DRAWING NO. D206-667-243	TITLE CROSSTUBE ASS'Y (206L HIGH AFT)	REV. C	<b>DART AEROSPACE LTD ENGINEERING ORDER</b>		D.E.O. NO. D206-667-243-C-1	SHEET NO. SHEET 1 OF 1	SCALE NTS
DRAWN <i>q</i>	CHECKED <i>ASS</i>	MFG. APPR. <i>AB</i>	APPROVED <i>MD</i>		DE APPR. <i>#</i>		
DATE 11.07.15	DATE 11.07.20	DATE 11.07.21	DATE 11/07/21		DATE 11.07.21

**PURPOSE:**

REPLACE MAGNOBOND WITH PROSEAL.

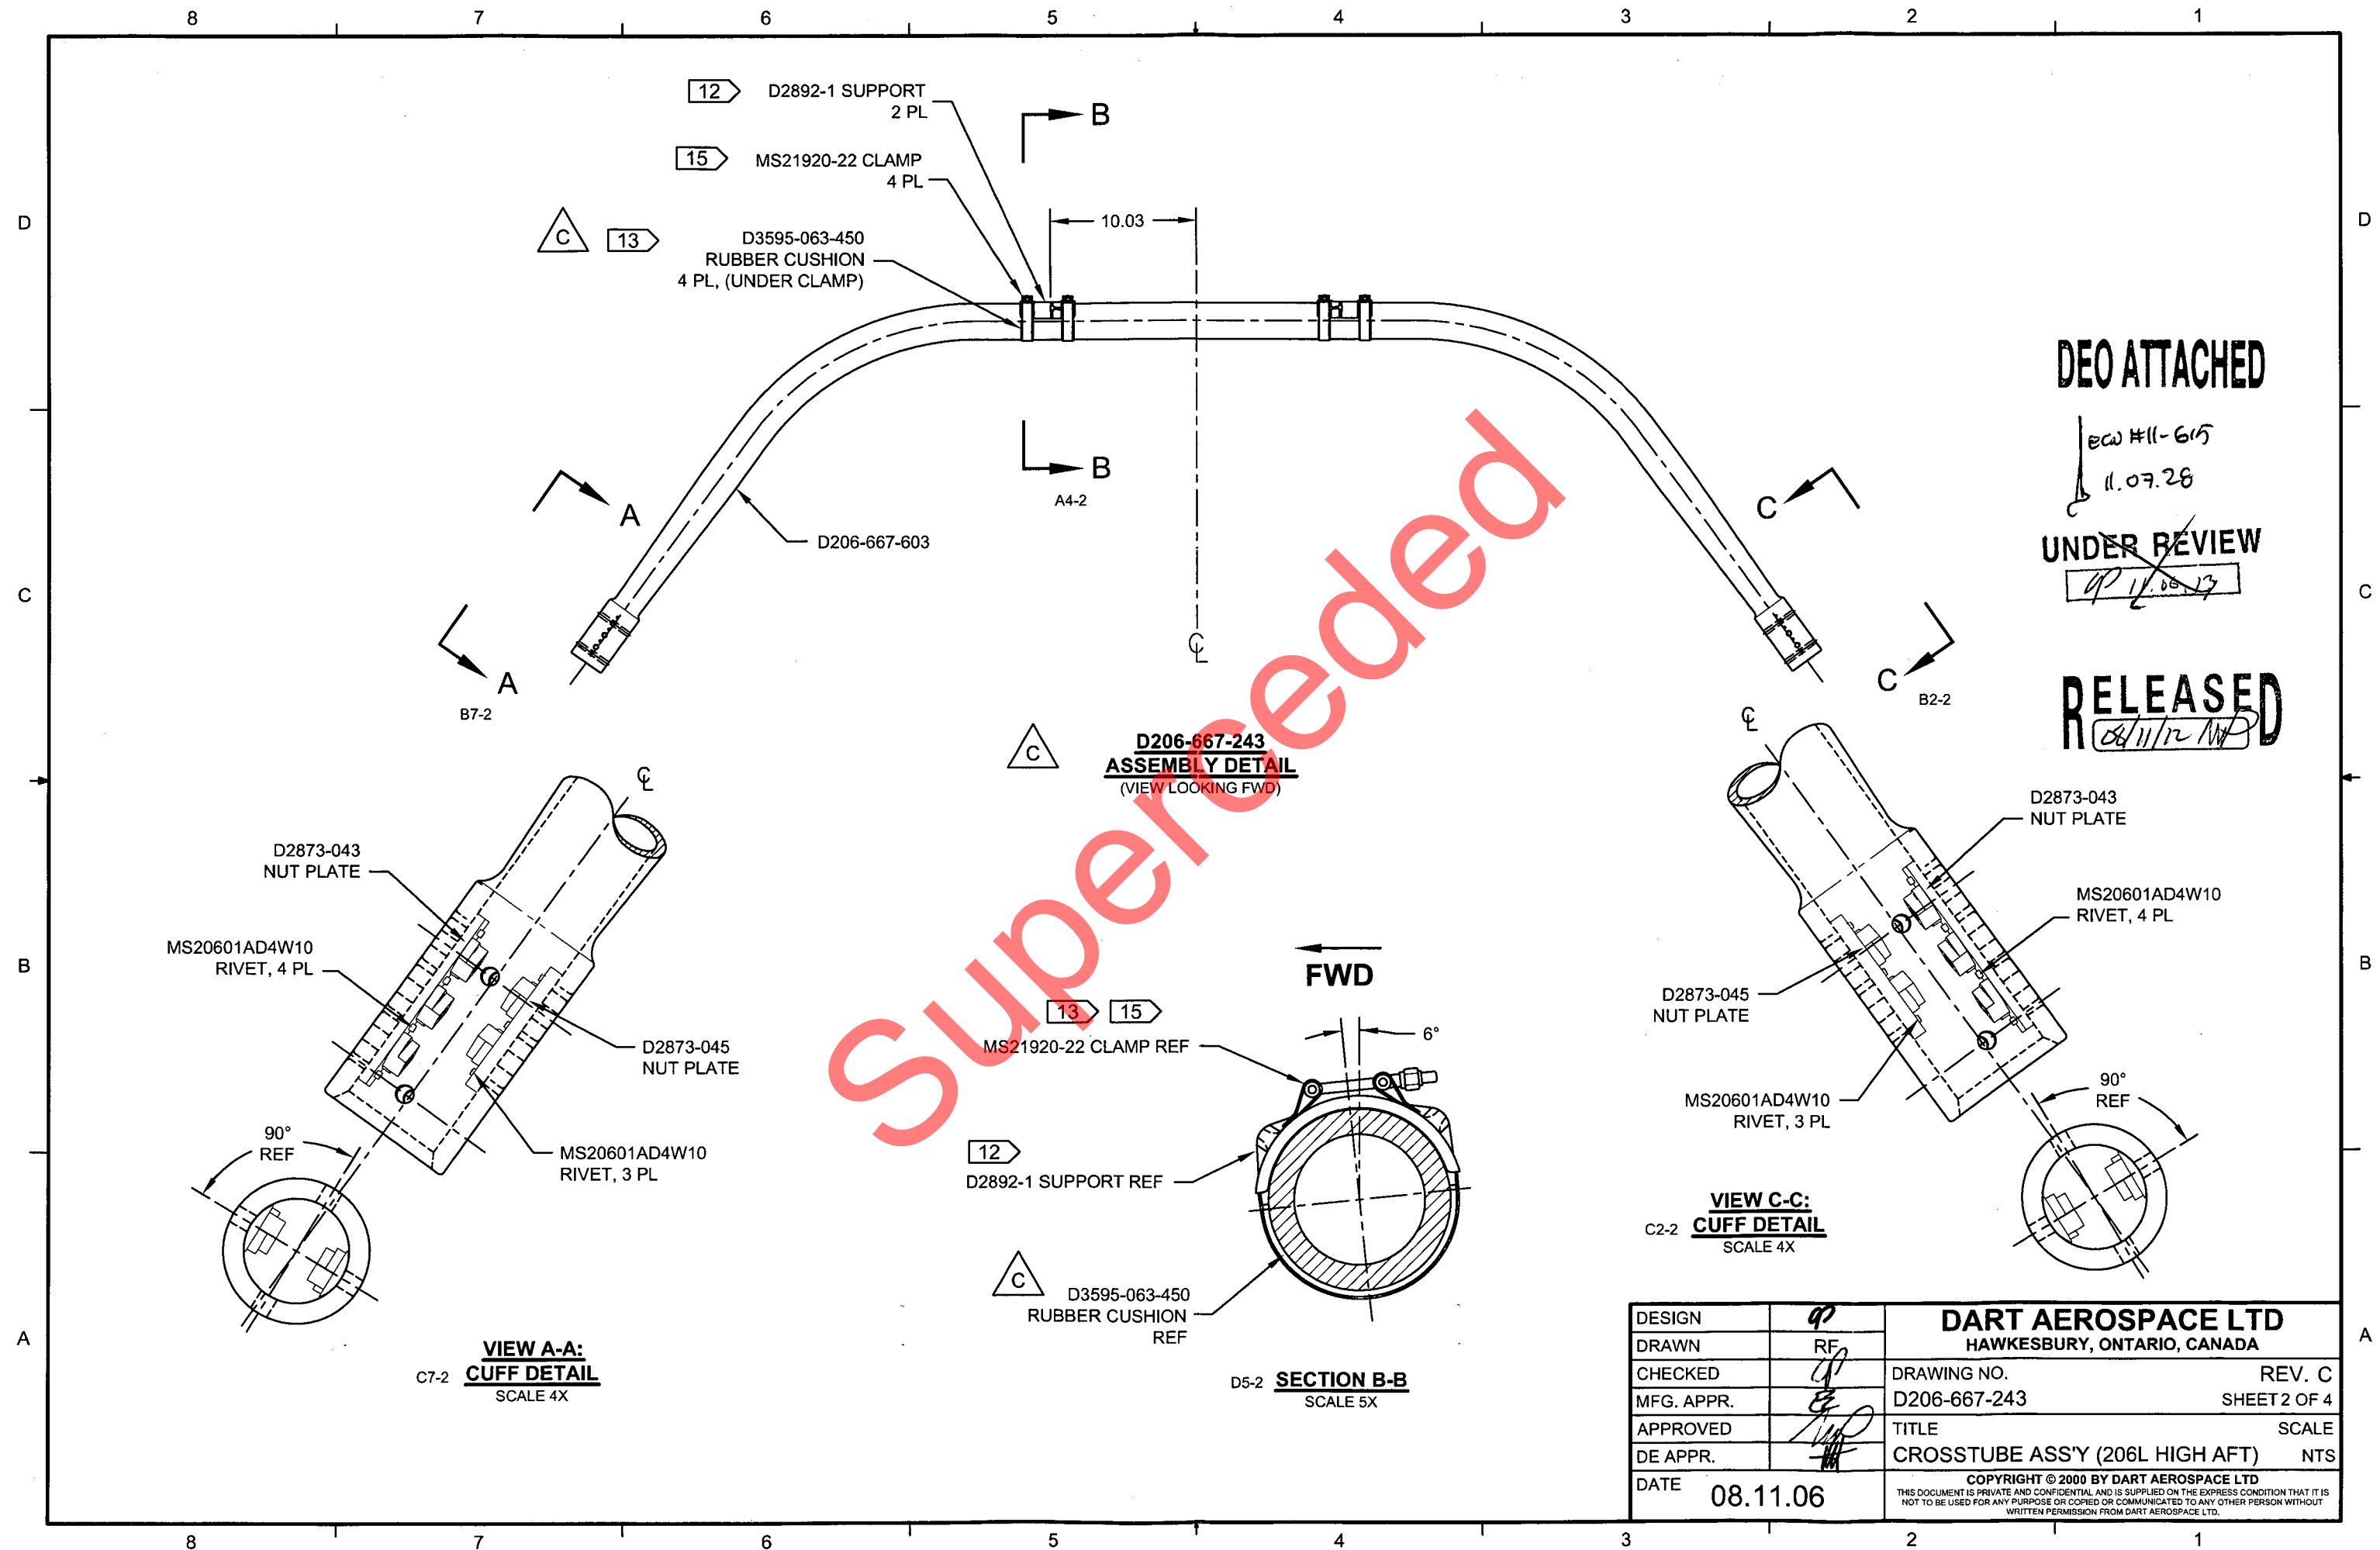
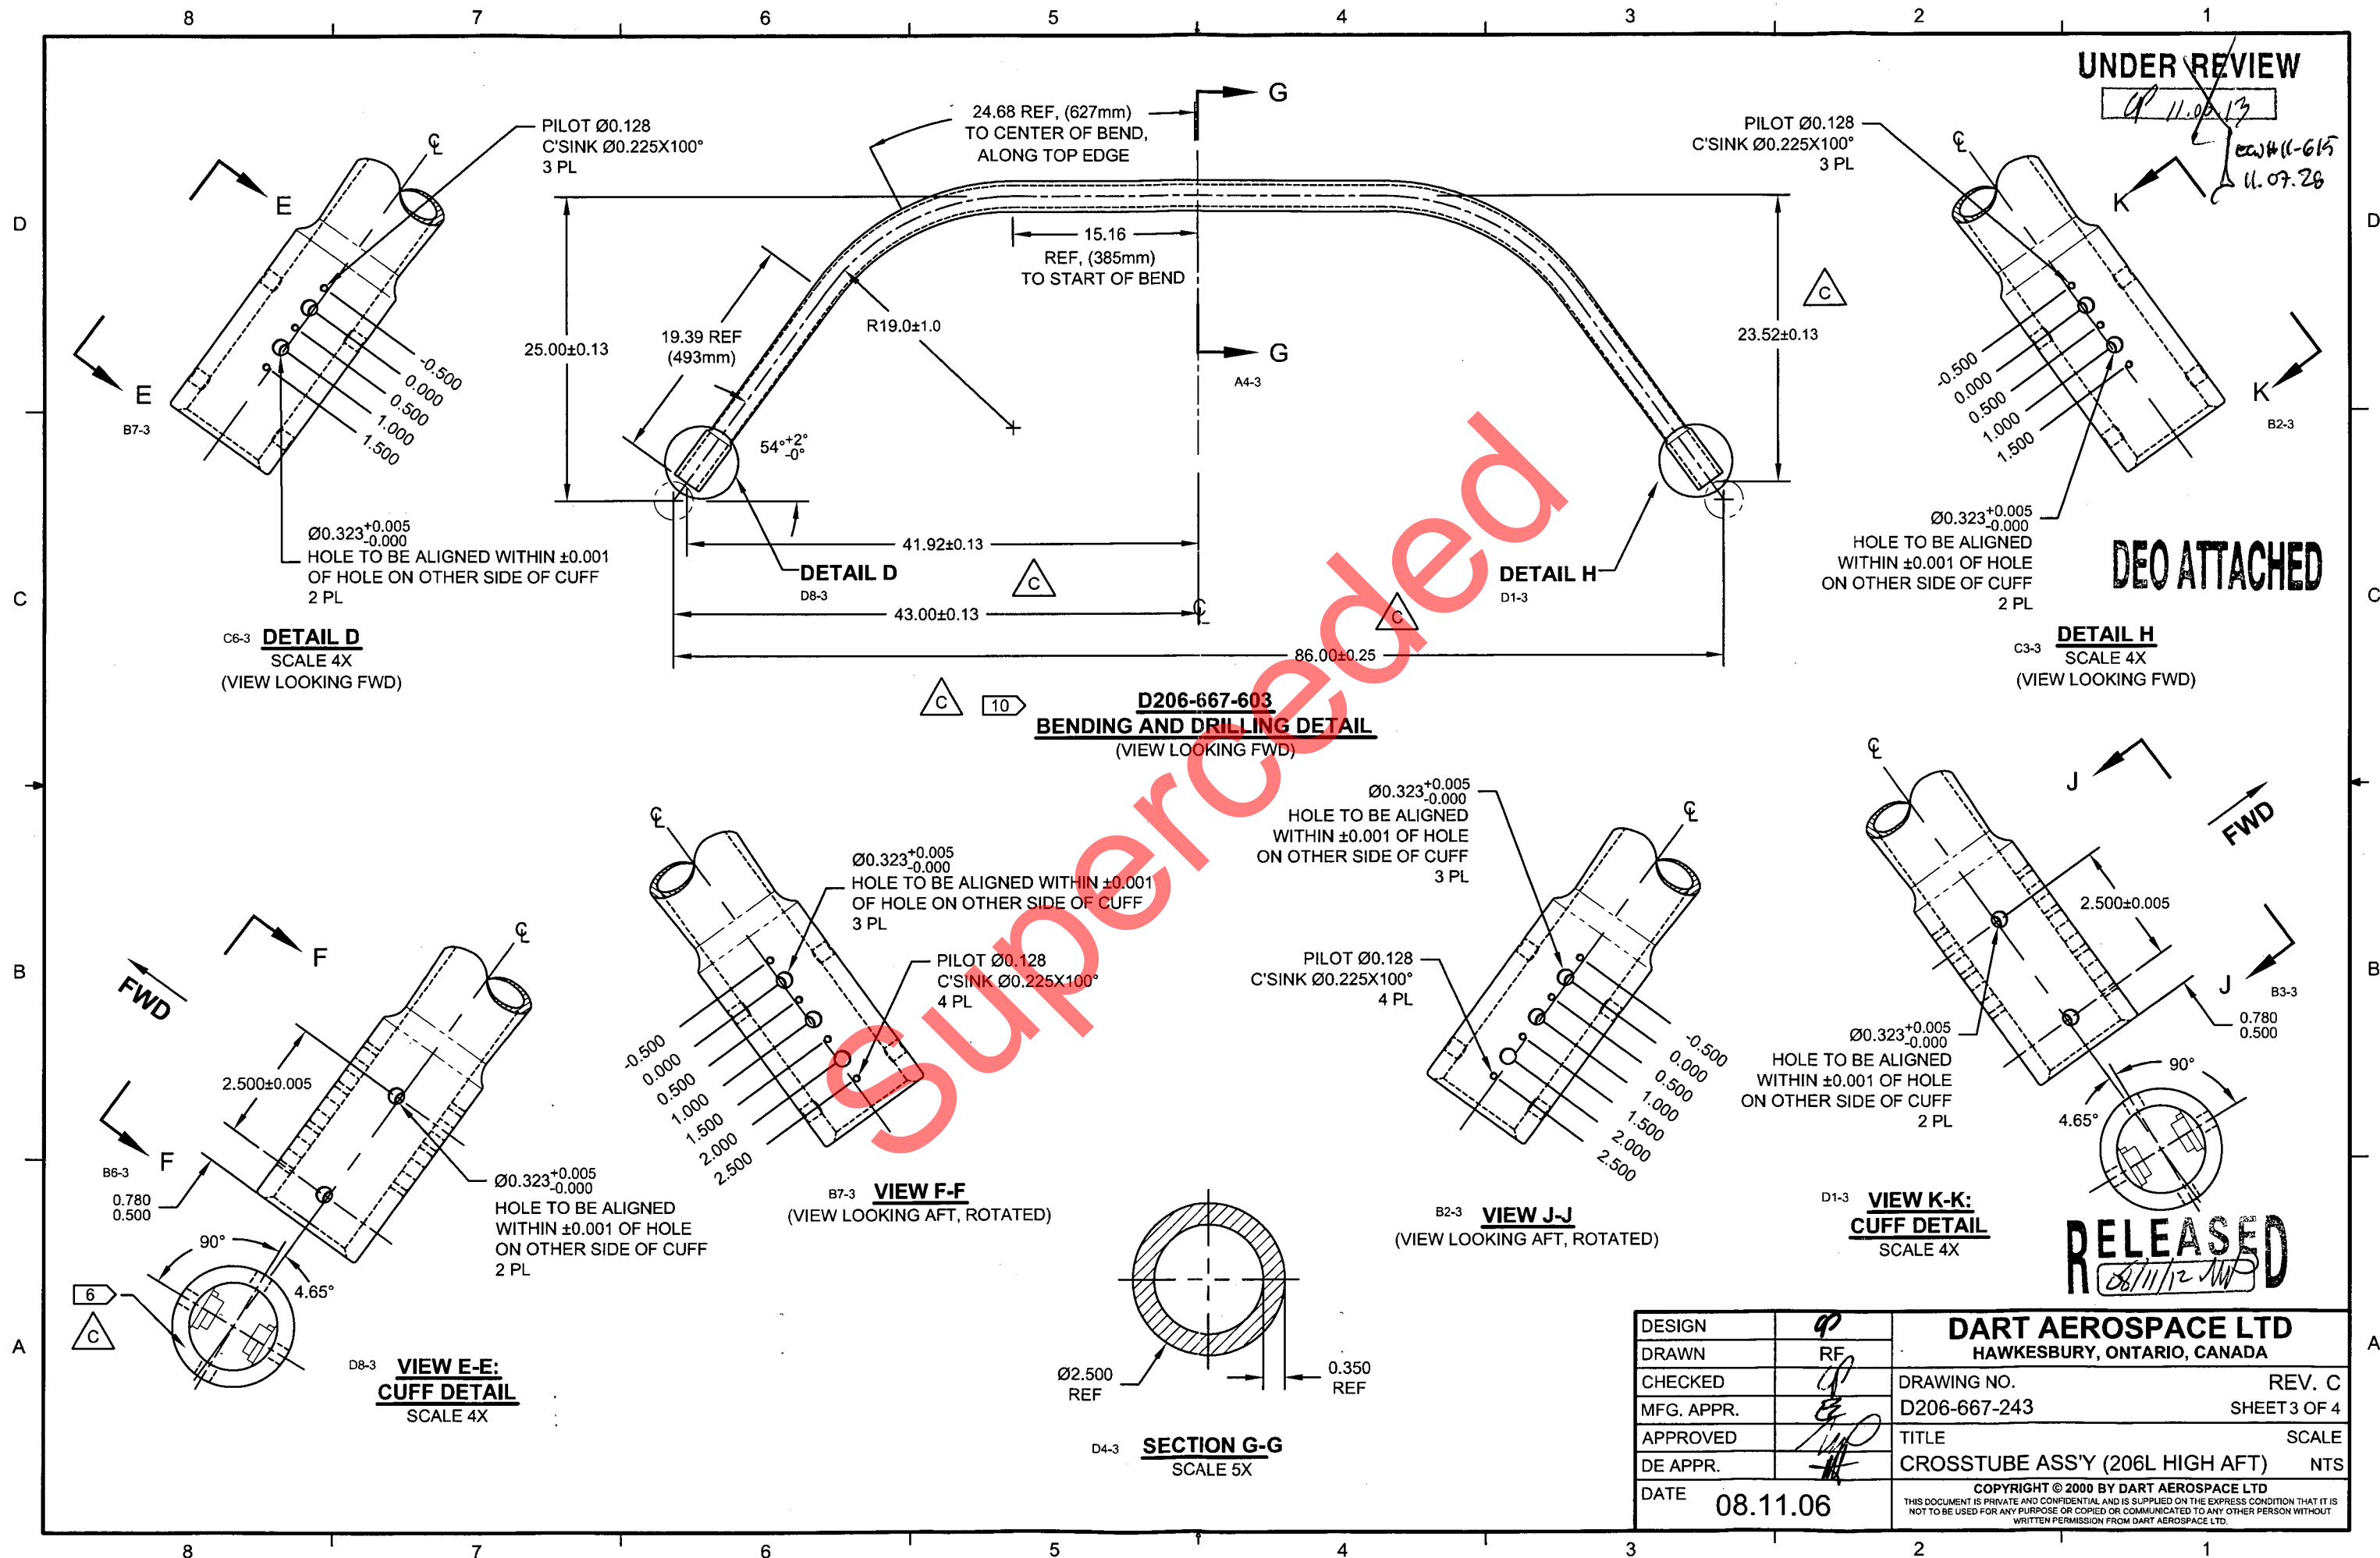
IS:

Item	Qty -243	Part Number	Description
9	A/R	PROSEAL 890 B-2	SEALANT, AMS-S-8802 CLASS B-2

WAS:

9	A/R	MAGNOBOND 6398	ROCKWELL SPECIFICATION RBO-120-023 ADHESIVE (TEXTRON/BELL SPEC. 299-947-100, TYPE II, CLASS 2 ADHESIVE)
---	-----	----------------	---

NOTE 12 & 15, SHEET 1 IS AMENDED AS FOLLOWS:

WAS:

- 12) INSTALL D2892-1 SUPPORT USING 0.03" TO 0.08" THICK LAYER OF MAGNOBOND 6398 PER QSI 015. LET CURE FOR 12 HOURS AFTER INSTALLATION AND PRIOR TO PACKAGING.
- 15) TORQUE CLAMPS 80 TO 100 IN-LB. ENSURE AT LEAST 1.5 THREADS SHOWING IN SAFETY AND THAT NUT HAS NOT BOTTOMED-OUT AFTER TORQUING.

- 12) TO INSTALL D2892-1 SUPPORT: ABRASE MATING SURFACE OF SUPPORT AND CROSSTUBE WITH 180-GRIT SANDPAPER AND REMOVE RESIDUE WITH MEK (OR EQUIVALENT). APPLY A 0.04" TO 0.07" THICK LAYER OF PROSEAL 890 CLASS B-2 (OR AMS-S-8802 CLASS B-2) SEALANT TO MATING SURFACE OF SUPPORT.
- 15) TORQUE CLAMPS 80 TO 100 IN-LB. ENSURE AT LEAST 1.5 THREADS SHOWING IN SAFETY AND THAT NUT HAS NOT BOTTOMED-OUT AFTER TORQUING. **PRIOR TO PACKAGING, RE-CHECK TORQUE ON CLAMPS AFTER PROSEAL 890 SEALANT HAS CURED FOR 72 HOURS.**
